Product Service Group CE Audio

Service Information

CORRECTION TO SERVICE MANUAL

CHANGES DURING PRODUCTION

MMPWR 100W MODULE - L/R AMP. & SUPPLY BOARD

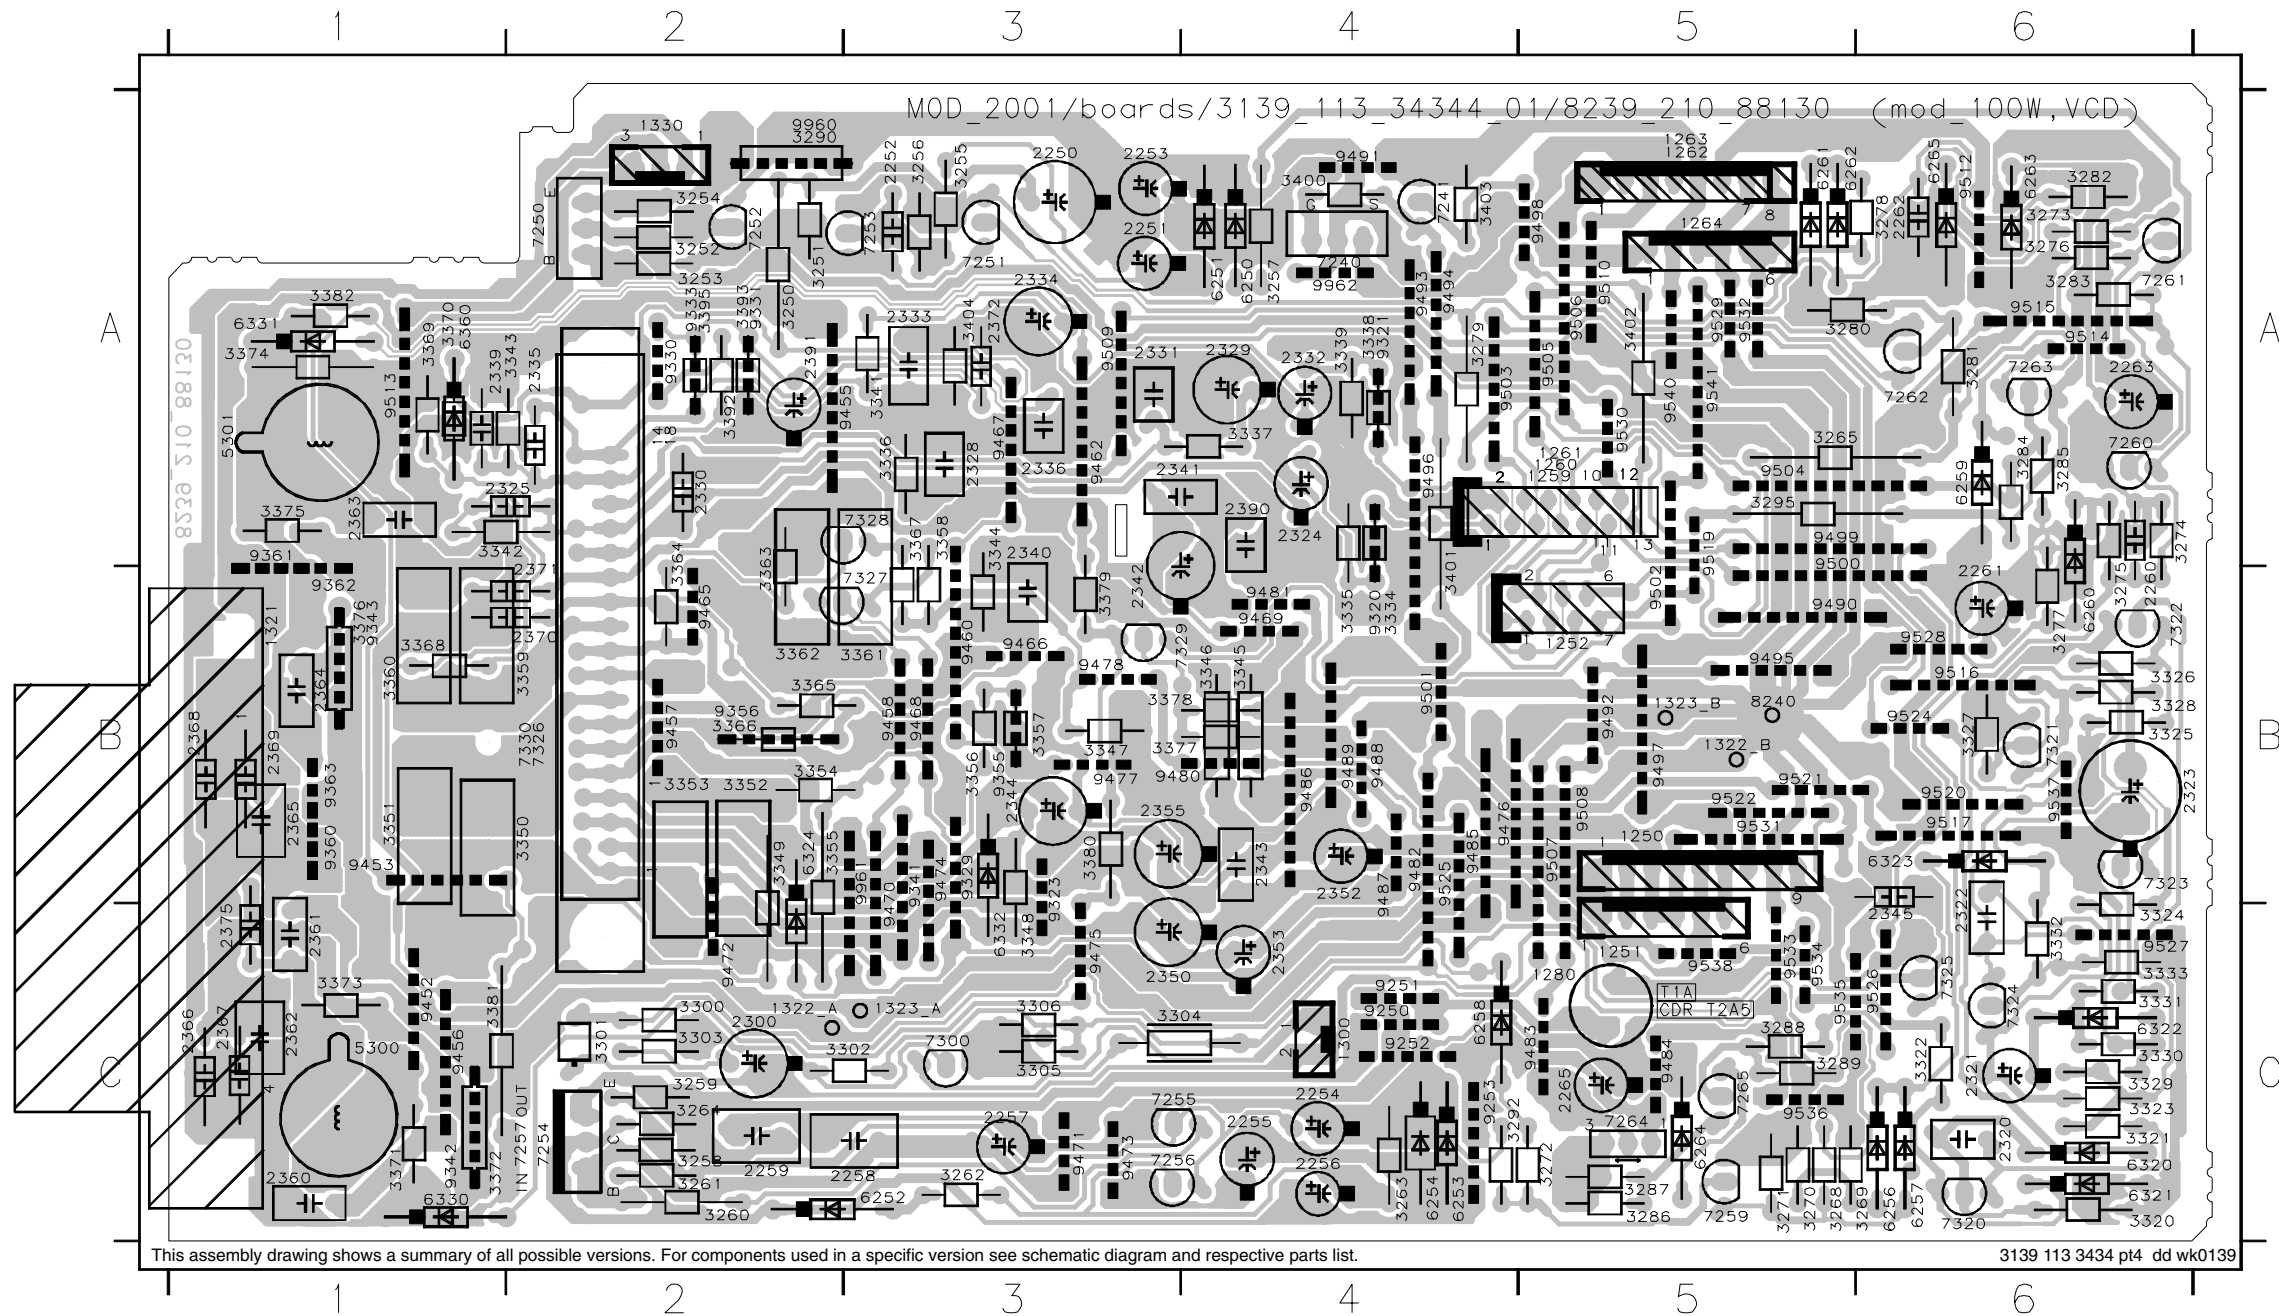
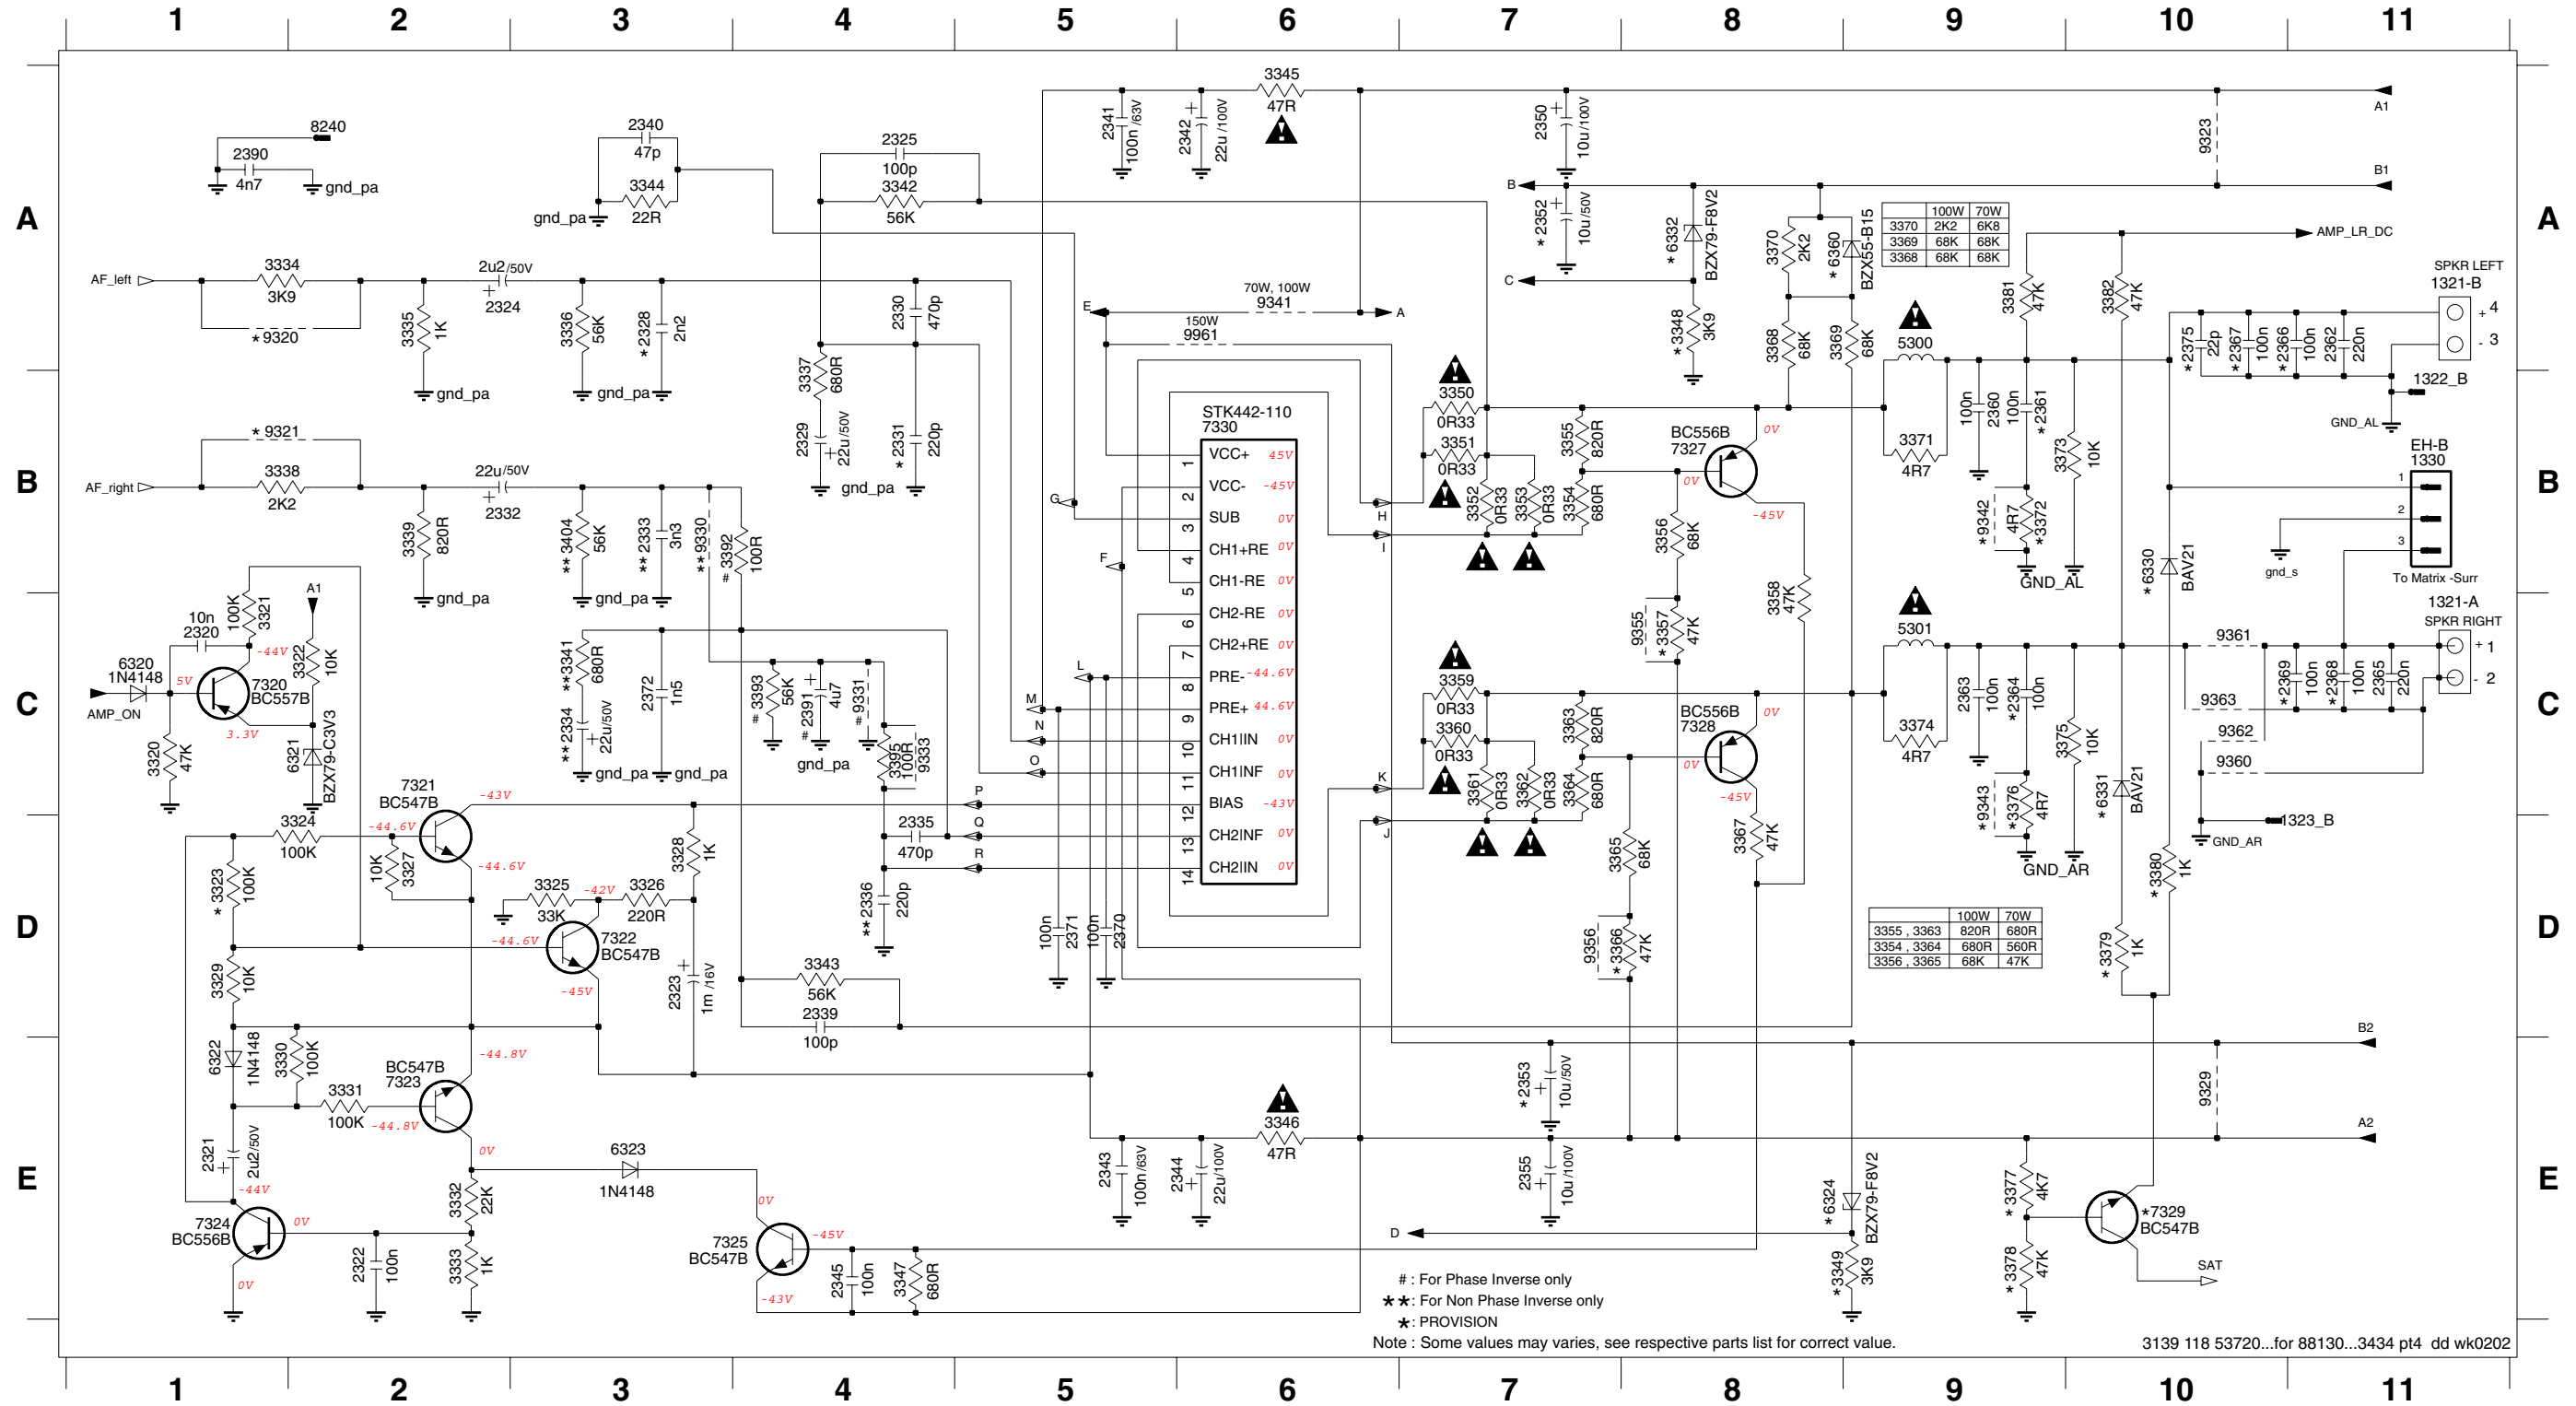
*From production week 0121 onwards the following has been changed to increase Fan speed.

Change 3304 4822 052 10108 Δ 1R 5% 0,33W
3305 4822 116 83876 270R 5% 0,5W
3306 4822 116 83876 270R 5% 0,5W

*From production week 0121 onwards the following has been changed for NTC sensitivity adjustment.

Add 3292 4822 116 52263 2k7 5% 0,5W
Change 6258 4822 130 34173 BZX79-B5V6

*From production week 0121 onwards pt.4 Board (identified by the last digit of the 12NC - 3139 113 34344) is introduced. For this reason new layout and circuit drawing are enclosed.

Reason : For EMC solution.

Add 2370 2020 561 90365 100nF +80/-20% 50V
2371 2020 561 90365 100nF +80/-20% 50V
2372 4822 126 12878 1,5nF 10% 16V
3395 4822 116 52175 100R 5% 0,5W
(For /22/30/34/37 only)

Add 9333 Bare wire
(For /21 only)

*From production week 0137 onwards the following has been changed for EMC performance.

Change 2330 4822 122 33519 470pF 10% 50V
2335 4822 122 33519 470pF 10% 50V
Delete 2328, 2331
(For /22/30/34/37 only)
